Highlights from the MMU Review of the Long Island Offshore Wind Export PPTP Report

NYISO Market Monitoring Unit

Potomac Economics

May 31, 2023

Benefit-Cost Ratio Over Time

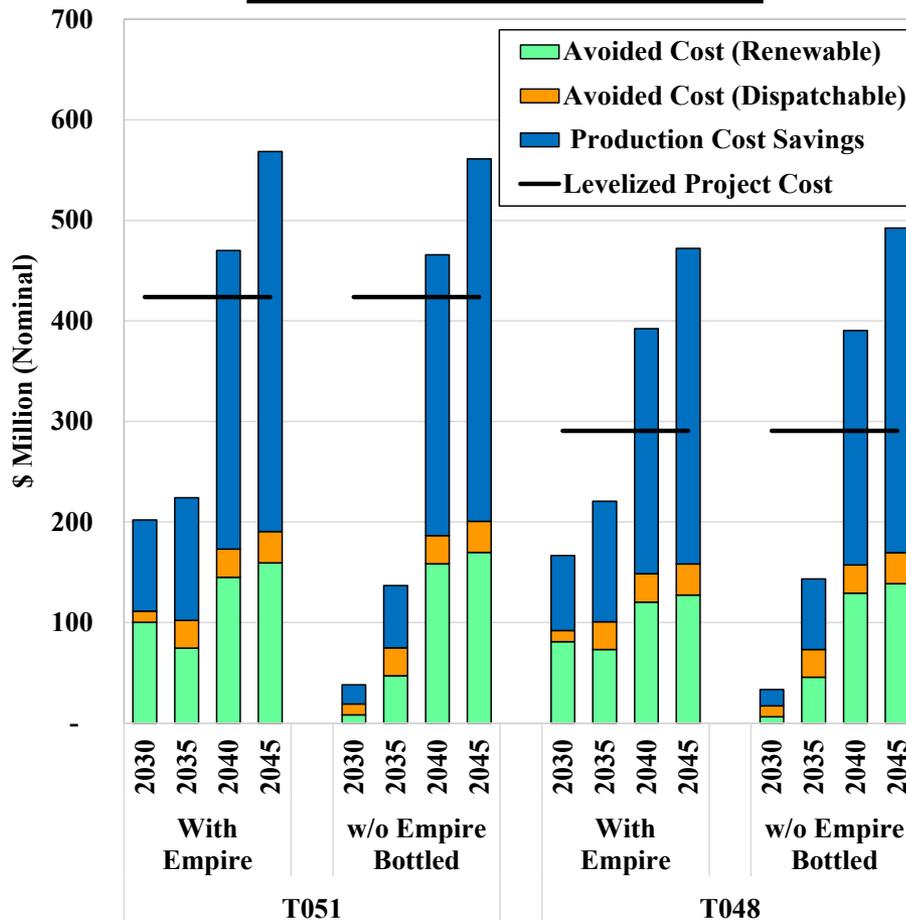
- In 2030, most benefits contingent on Empire II connecting at bottled interconnection point
- In 2035, B-C ratios still well below 1.0
- In 2040 & 2045, benefits depend on DEFR cost of \$150/MWh
- T048 estimated to be the lowest cost project, resulting in higher B-C ratios

INREC Cost of Tx versus Clean Technologies

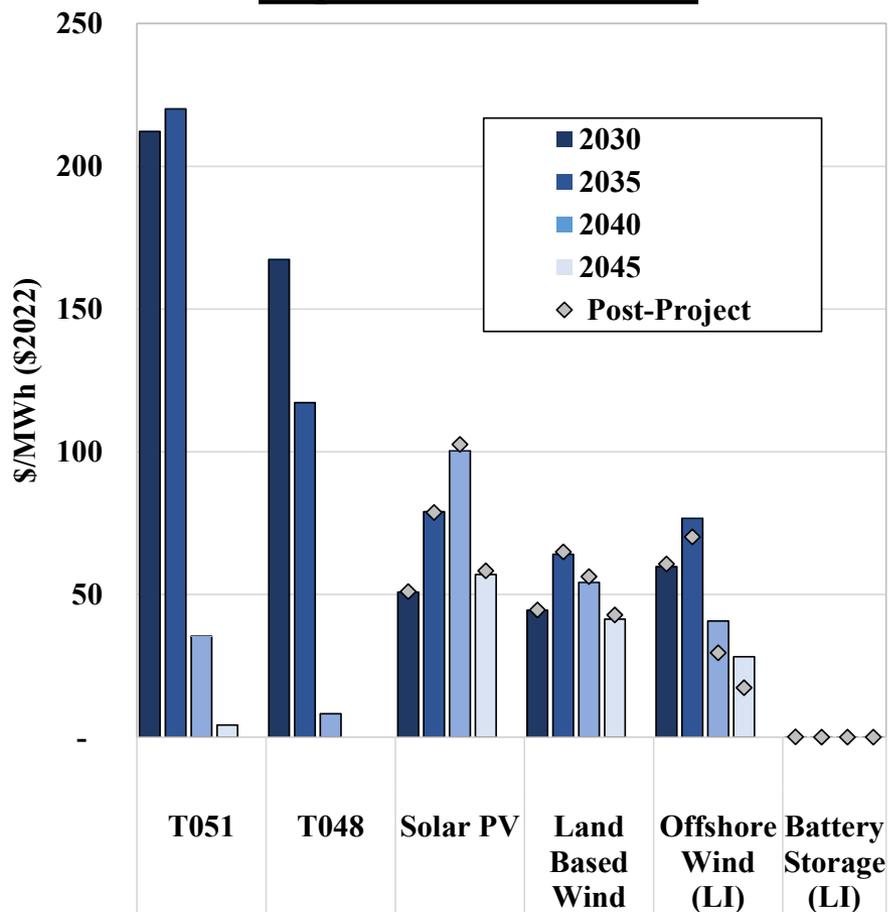
- 2030s Tx projects higher-cost than renew & battery
 - ✓ Avoided Cost (Renew) is not cost-effective
- 2040s Tx projects cost fall below wind and solar due to DEFR assumptions
- Tx project impact on OSW INREC cost:
 - ✓ \$0/MWh in 2030
 - ✓ \$7/MWh in 2035
- Higher battery penetration would be efficient
